## REVISED RESPONSE TO REQUEST FOR ADDITIONAL INFORMATION

### APR1400 Design Certification

Docket No. 52-046

**RAI No.:** 252-8299  
**SRP Section:** 03.07.02 – Seismic System Analysis  
**Application Section:** 3.7.2  
**Date of RAI Issue:** 10/19/2015

Figure 4. Tapered Section in Primary Shield Wall

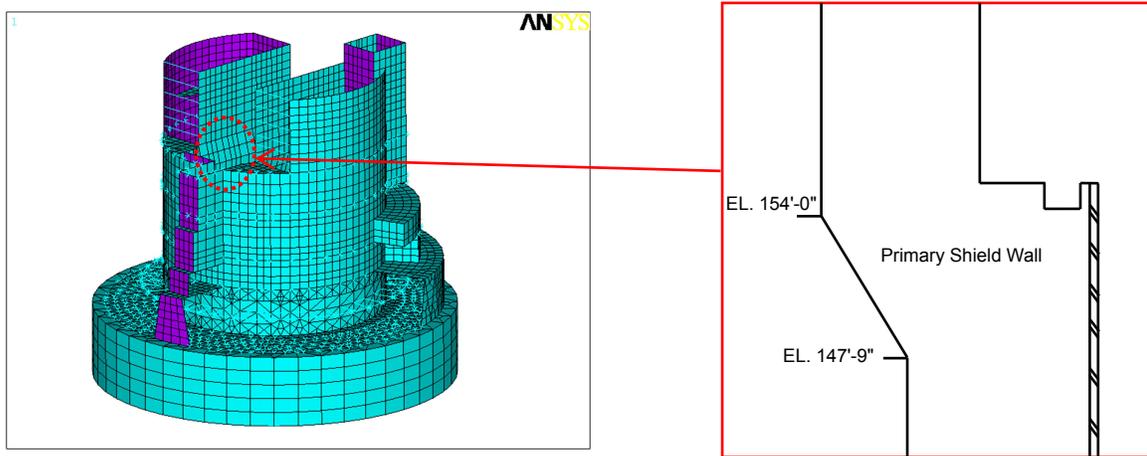
As described in Section 3.2.10 and shown Figure 3-3 in APR1400-E-S-NR-14002-P, shell elements are used to model the shield wall portion of the primary shield wall (PSW) from EL 130' to EL 191.' Given the geometry of the PSW, the use of thick shell elements may be more appropriate for this portion of the PSW. he geometry of the PSW, the use of thick shell elements may be more appropriate for this portion of the PSW. Additionally, based on Figure 3-3, a portion of these walls modeled with shell elements, appears to be not in plane with respect to the plane of each respective wall. Therefore to assist the staff in evaluating the adequacy of the FEM for the PSW, the staff requests the applicant to clarify why the shell element selected for the PSW model is appropriate as opposed to using a thick shell element formulation. Additionally, please describe the modeling approach and the basis of the shell portion of the walls including the location of plates oriented in non-parallel planes.

- c) The original SASSI program was developed in the 1980's and has only the LCCT9 thin shell element, which was adopted from the SAP IV structural analysis program. This same version of the SASSI code was adopted by many company-specific versions of SASSI. ACS SASSI 2.3 also has only the LCCT9 thin shell element. Many versions of SASSI, including ACS SASSI 2.3, do not have thick shell element available for structural modeling. This is the reason why thick shell elements have not been used for modeling the PSW by the ANSYS program.

Use of thick or thin shell elements does not significantly affect the overall structural stiffness since the main stiffness of the shell structures (containment shell, PSW, SSW, etc.) are primarily due to in-plane stiffness.

The thickness and center axis of the PSW section are changed over EL. 147'-9" through EL. 154'-0", as shown in Figure 4. The portion of wall which is not in plane with respect to the plane of respective walls in Figure 3-3 of APR1400-E-S-NR-14002-P was intentionally modeled to represent the contour of the PSW.

Figure 5. Connection between RCS Supports and Solid Elements

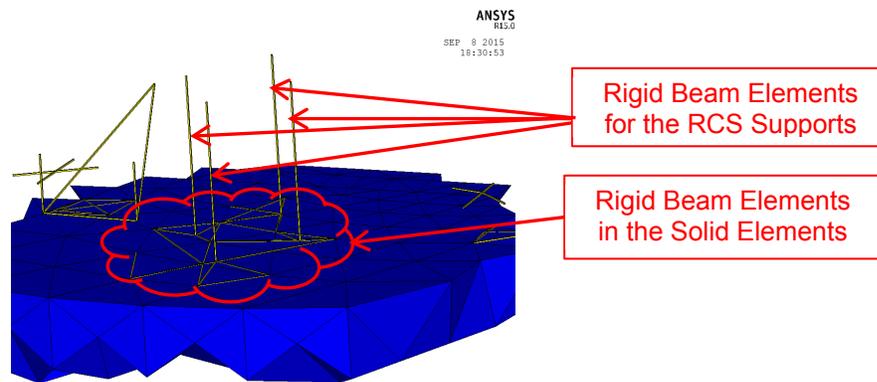
Staff review of APR1400-E-S-NR-14002-P finds that the nuclear island finite element model includes locations at which beam elements connect with solid elements (e.g. connections between the reactor coolant system model and the containment internal structure model). However, the staff did not find a description of how the degree of freedom compatibility is addressed for transitions between beam and solid elements. Therefore the staff requests the applicant to provide such description, including a graphical representation of the transition between beam and solid elements.

- d) The degrees of freedom compatibility condition between the beam elements of the reactor coolant system (RCS) and solid elements of the primary shield wall (PSW) and the secondary shield wall (SSW) was satisfied by using the rigid beam elements at the beam-to-wall support points covering the footprint of the RCS support brackets. The RCS supports are modeled as rigid beam elements and connected with other rigid beam elements in the solid elements which represent the PSW and the SSW.

Figure 5 shows the connection between the RCS supports (rigid beam) and the building model (solid elements). Technical report APR1400-E-S-NR-14002-P will be revised, as indicated in Attachment 3 to this response to incorporate the description of the beam-to-solid element connection.
